Planning Commission Issues Report

Subject: Ordinance Amendment Issues Report

Meeting Date: November 24, 2014

Petition: **P.Z. 11-2014 THF Chesterfield Development LLC (The Commons)**

Exhibit "A"

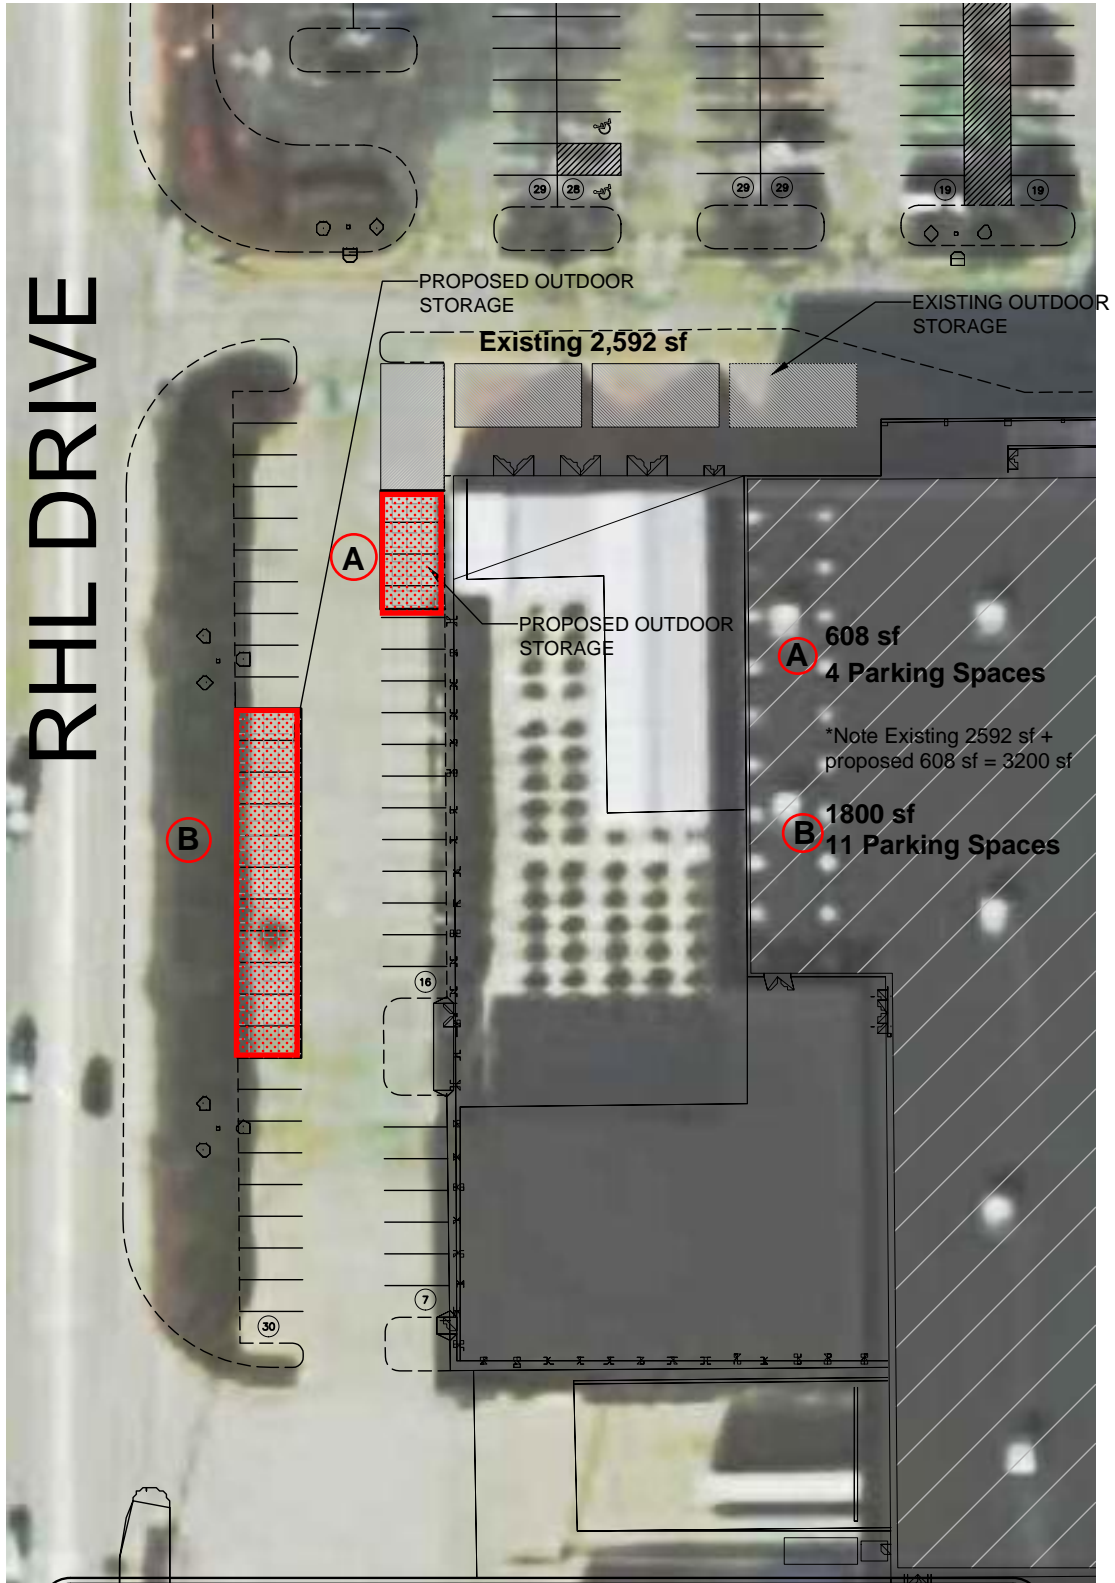
The height restriction will ensure that materials in these areas, especially along the western property line, are better screened by existing landscaping which can be seen in the image below. Storage Area B, as denoted on Exhibit A attached to this report has also been moved southward to be located in the middle of the existing parking area to provide maximum separation from both entrances to the property from RHL Drive.

(Existing) I.B.6.a. The area to be utilized for seasonal outdoor storage shall be limited to 3,200 sq. ft. as delineated on the attached Exhibit A.

(Proposed) I.B.6.a. The area to be utilized for seasonal outdoor storage shall be limited to 5,000 sq. ft. and all materials stored outside the fenced area shall have a maximum height of eight (8) feet as delineated on the attached *(revised)* Exhibit A.

Exhibit "B"

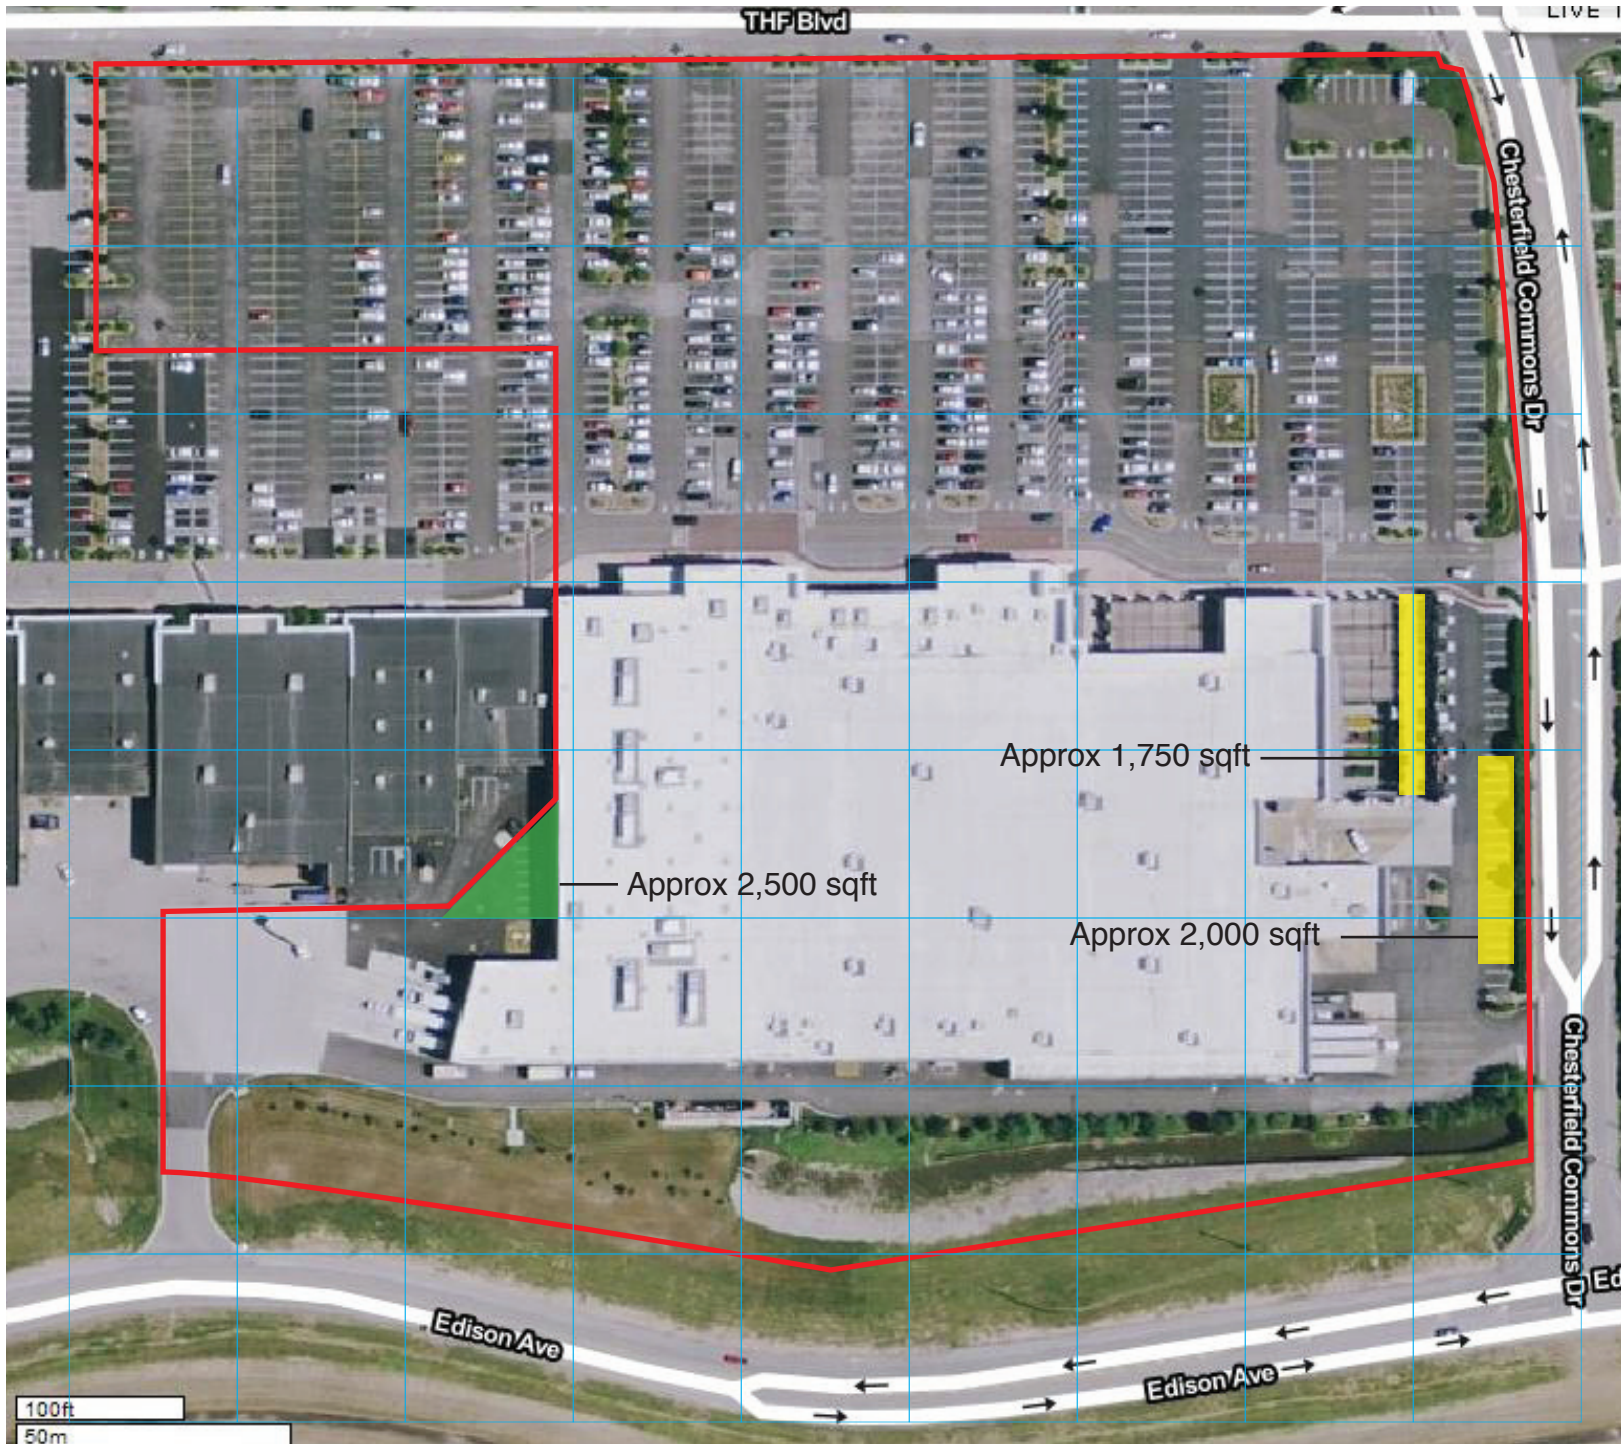
Although the outdoor storage areas located at the westernmost anchor tenant have been reduced, there has been a substantial addition of outdoor storage areas requested for the easternmost anchor tenant. Details of this request can be seen in the attached Petitioner Revised Request Letter and Exhibit B. The easternmost tenant space, currently occupied by Walmart, is currently in violation of the existing ordinance for outdoor storage. The majority of the violation can be seen in the image below. Walmart has joined the active petition for Chesterfield Commons in an effort to abate this active violation. The outdoor storage areas seen to be occupied by storage containers in the image below also illustrates a portion of the outdoor storage areas in the current request for this specific tenant.

f. The area to be utilized for seasonal outdoor storage for the period of October 15th of one year until January 31st of the following year shall be limited to 3,750 sq. ft. as delineated on the attached Exhibit B.

g. The area to be utilized for year-round outdoor storage shall be limited to 2,500 sq. ft. as delineated on the attached Exhibit B.

h. Outdoor storage shall be permitted in portable containers designed, constructed and used for temporary storage of goods, merchandise and supplies offered for sale or used by the eastern-most anchor. No dumpster or receptacle used for the disposal of solid waste may be used for outdoor storage.
